9.3 NO. 242 (LOT: 2; D/P: 1641) LAKE STREET, PERTH - PROPOSED ALTERATIONS AND ADDITIONS TO A SINGLE HOUSE AND SHOP

To consider an application for development approval for alterations and additions to an existing shop and single house at No. 242 Lake Street, Perth (the subject site).

Upper level floor Plan scale 1 : 100

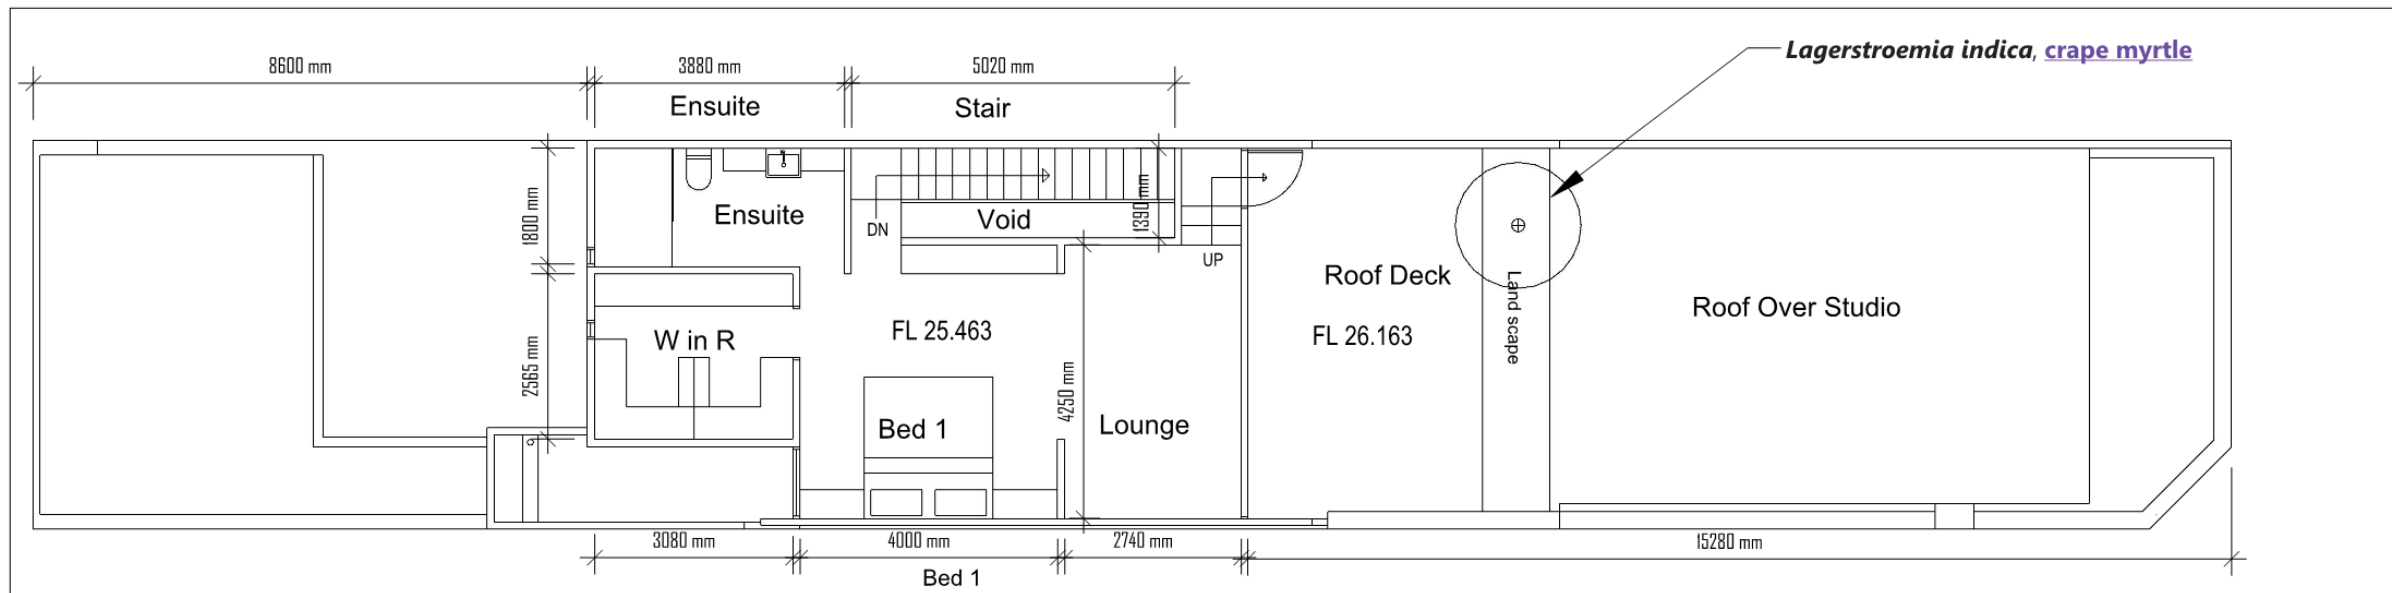
The R Codes deemed-to-comply standards relating to visual privacy outline that the upper floor roof deck should provide a 7.5 metre cone of vision setback to the south eastern lot boundary and the application proposes a nil setback.

Comments Received Expressing Concern:	Administration Comment:
<p><u>Visual Privacy</u></p> <p>Concerns that the upper floor deck area on the southern elevation would create a privacy issue for the adjoining properties to the south east.</p>	<p>The R Codes deemed-to-comply standards relating to visual privacy outline that the upper floor roof deck should provide a 7.5 metre cone of vision setback to the south eastern lot boundary and the application proposes a nil setback.</p> <p>Administration agrees with the submissions received during the consultation period outlining that the proposed upper floor roof deck cone of vision would result in direct overlooking to the adjoining south eastern properties primary outdoor living area and as a result, would not satisfy the design principles of the R Codes.</p> <p>Should the application be approved, it is recommended that a condition be imposed requiring the applicant to submit amended plans prior to the issue of a building permit which increases the height of the balustrading along the south eastern side of the upper floor roof deck from 1 metre to 1.6 metres to mitigate direct overlooking to the adjoining property to the south.</p>

- Modify the mid level bedroom 2 window vertical screens to provide a 4.5 metre cone of vision setback to the south eastern lot boundary in order to satisfy the deemed-to-comply standards of the R Codes; and
- Increase the height of the solid balustrading along the south eastern side of the upper floor roof deck from 1 metre to 1.6 metres to mitigate direct overlooking to the adjoining property to the south.

Mid level floor Plan scale 1 : 100

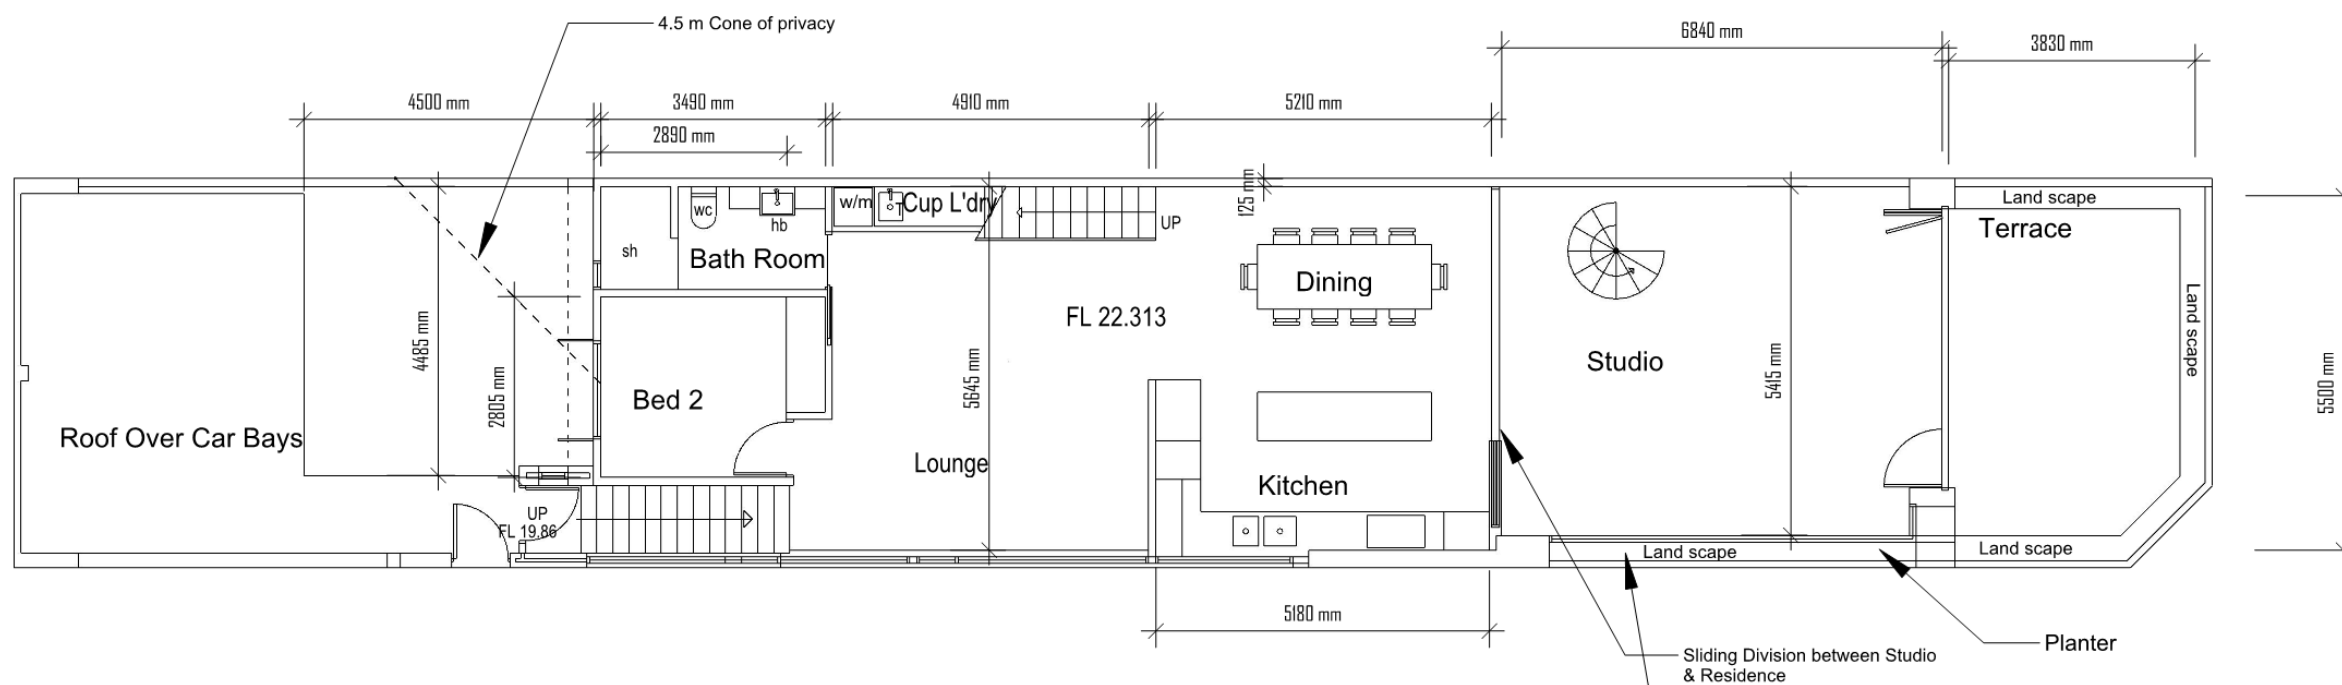
- Additional windows facing Lake Street should be added at the upper level to increase the level of passive surveillance of the streetscape;
- Confirmation should be provided regarding how the mid level terrace planter would be accessed and maintained;

- There are further opportunities for meaningful on-structure planting on the mid level terrace and upper level roof deck;
- Consider providing a setback to the south eastern lot boundary at the upper level to reduce the bulk, scale and overshadowing impact on the adjacent property;

The R Codes deemed-to-comply standards relating to visual privacy outline that the mid level bedroom 2 window should provide a 4.5 metre cone of vision setback to the south eastern lot boundary and the application proposes a 4.4 metre setback.

The proposed plans show a 4.5 metre cone of vision to the south eastern lot boundary from the mid level bedroom 2 window. Administration has identified that this setback measures to 4.4 metres rather than 4.5 metres.

- a) The mid level bedroom 2 window shroud shall be extended to ensure that a 4.5 metre cone of vision setback is provided from this window to the south eastern lot boundary, in accordance with the deemed-to-comply standards of the Residential Design Codes Volume 1, Clause 5.4.1 (Visual Privacy), to the satisfaction of the City; and
- b) The height of the solid balustrading along the south eastern side of the upper floor roof deck shall be increased from 1 metre to 1.6 metres above the finished floor level of the roof deck, in accordance with the deemed-to-comply standards of the Residential Design Codes Volume 1, Clause 5.4.1 (Visual Privacy), to the satisfaction of the City.

Over Shadow Plan scale 1 : 200

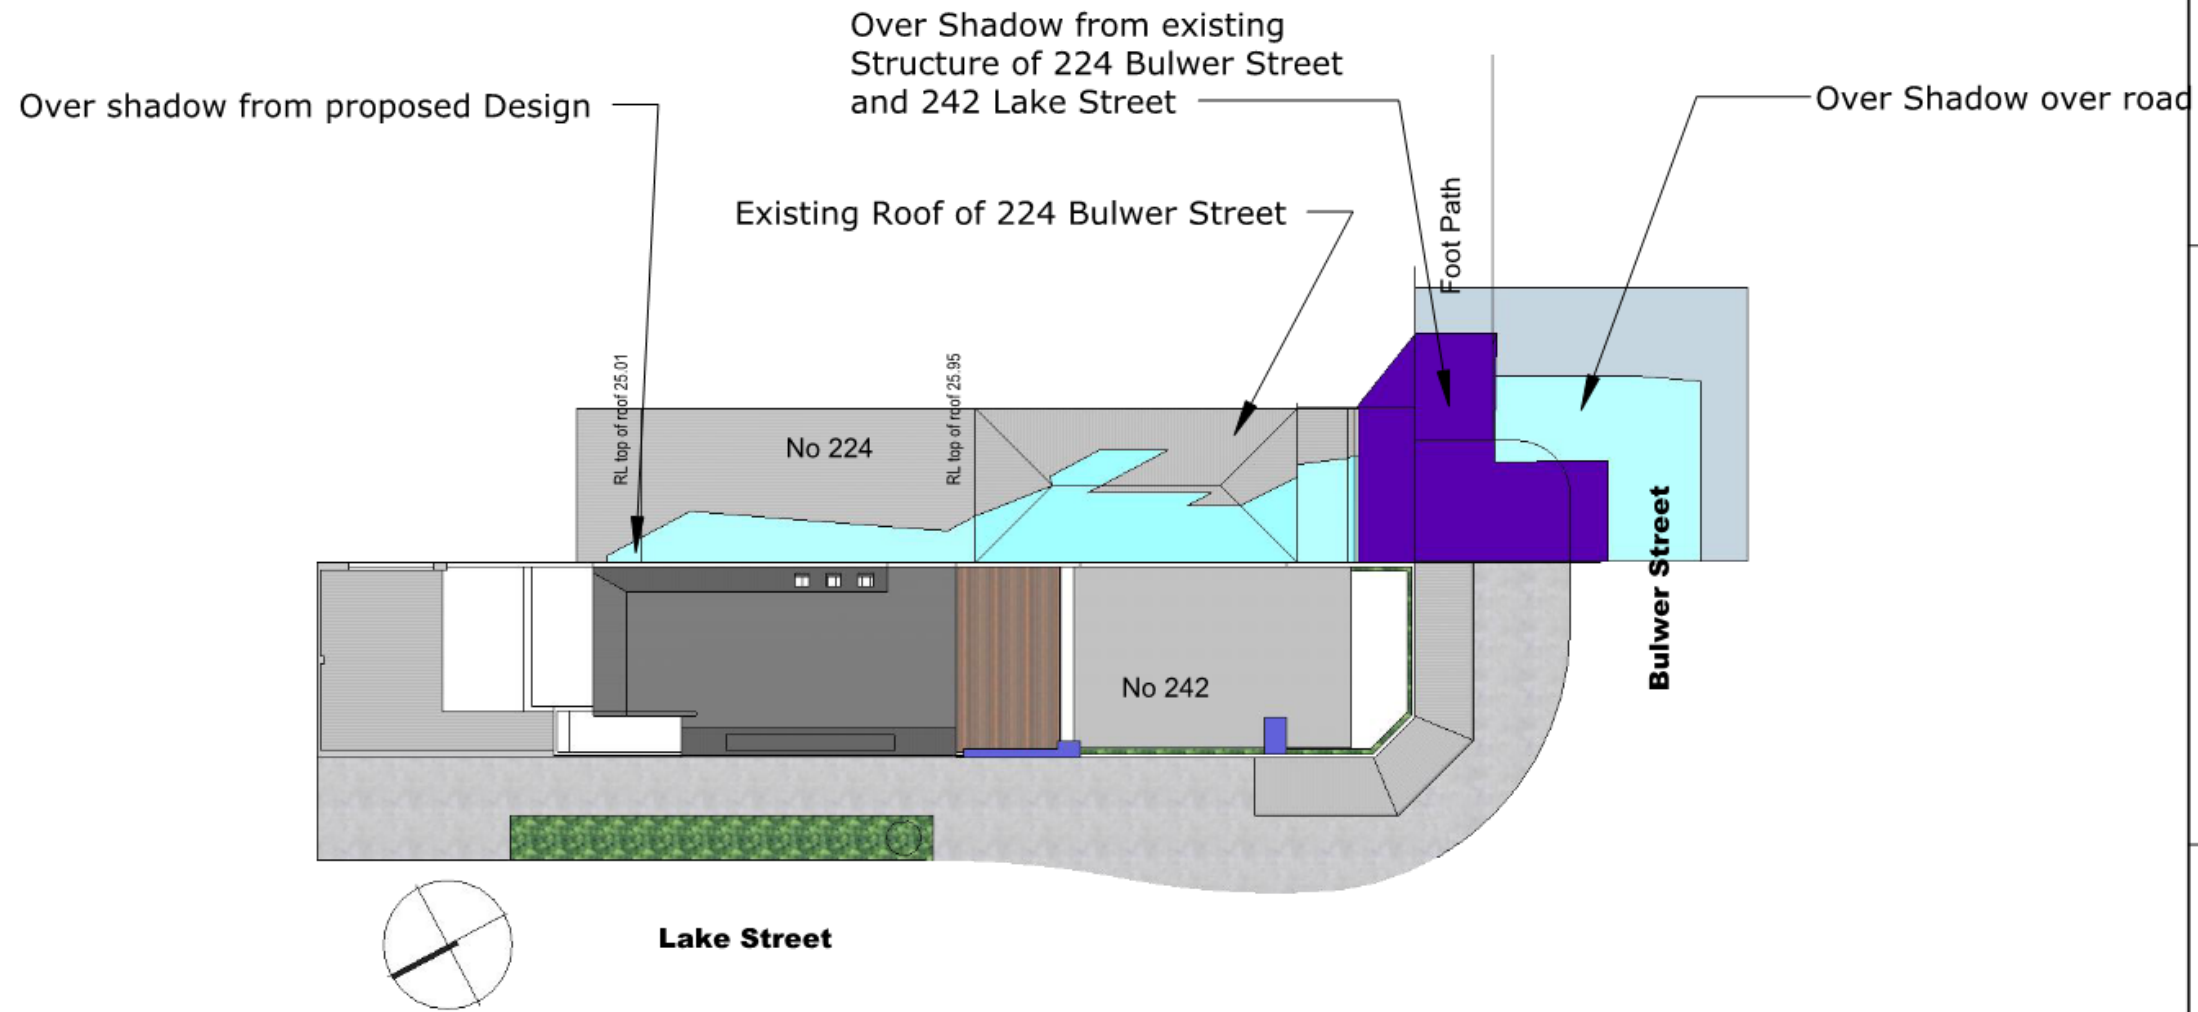
The applicant's written response to the submissions received which is included in Attachment 7 outlines that although the development would result in some overshadowing of the roof of the adjoining south eastern dwelling, large portions would remain free of shadow due to the height of the adjoining dwelling's roof comparative to the proposed development.

The proposal will have some over shadowing of the neighbouring property of 224 Bulwer Street, but the addition shadowing is over roof only. As the front entry court yard of 224 Bulwer Street is currently fully shaded by the existing built form of 224 Bulwer Street and 242 Lake Street (see over shadow Plan).

The applicant submitted further amended plans which are included in **Attachment 2** in response which reduced the overall amount of shadow cast by the proposed development by a further 7.3 square metres. The acceptability of the impact of the development on solar access to adjoining dwellings is discussed in the Comment section of this report.
